Benton County Planning Board

**SITE PLAN REVIEW (fka-Large Scale Development) – MAJOR AMENDMENT
PLANNER’S PUBLIC HEARING REPORT**

15206 Silica Street, Rogers 72756

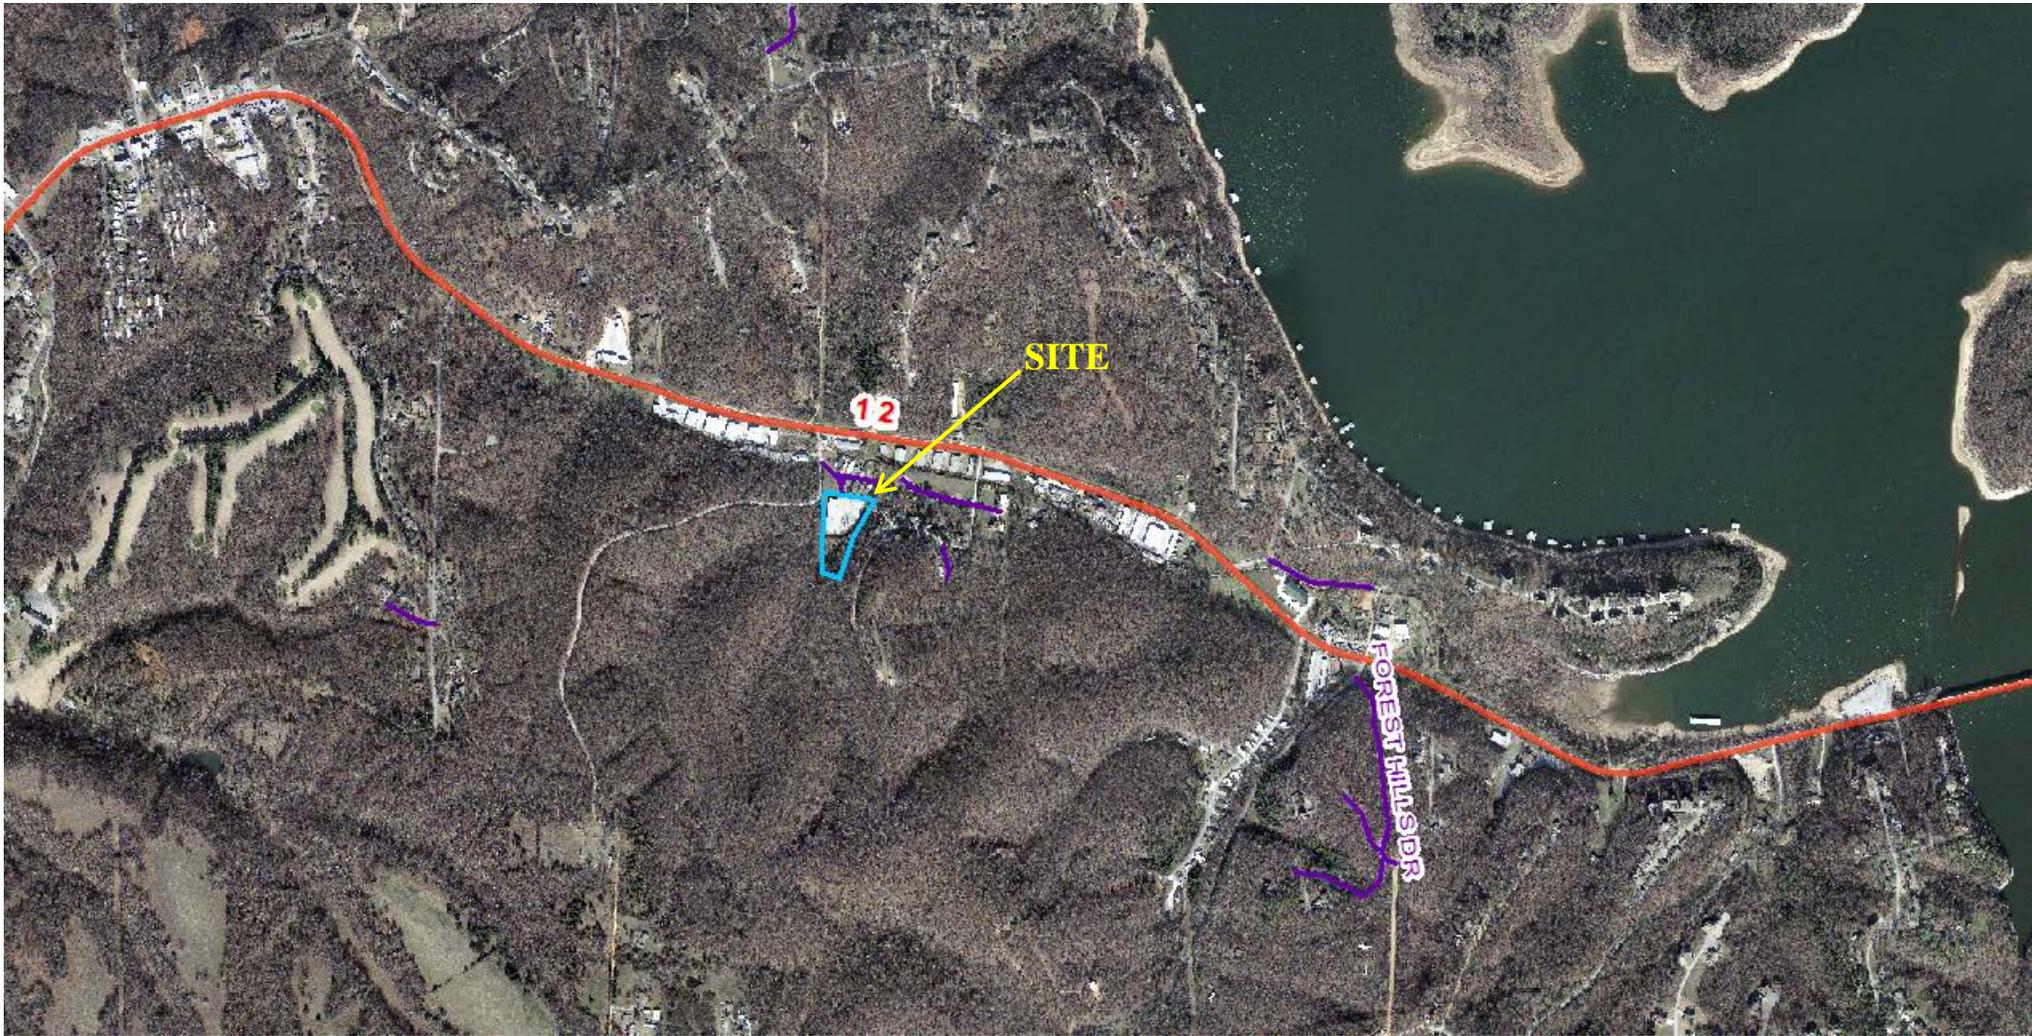
- A. Site Plan revisions; Location of all current or future outdoor lighting, correct parcel ID number, and any required screening and/or buffering stipulated by the Board.

- B. Revise text note detailing parking variance being sought as part of the LSD Amendment to include "Benton County Planning Division Variance case #15-137"

- C. Revise text note detailing building to property line setback being sought as part of the LSD Amendment to include "Benton County Planning Division Variance case #15-161"

- D. ADEQ Notice of Automatic Coverage for site 1 to 5 acres shall be submitted to Staff
- E. Prior to issuance of a Planning Board decision letter applicant shall mark or flag the 2 inch septic force main line as detailed on the septic permit information to protect this infrastructure from damage during the construction process.

- F. Applicant's engineer shall provide hydraulic analysis/report providing evidence that the current culvert configuration (three (3x) 36 inch CMP culverts) will be able to carry runoff in the stream channel.

- G. Site plan shall be revised in regard to the stream crossing diagram in accordance with the Metal Pipe Design Manual. Minimum depth of pavement required over a corrugated metal pipe to carry an 80,000 lb. load is 12 inches from top of the pipe to the top of the rigid pavement; current site plan diagram shows 10 inches.
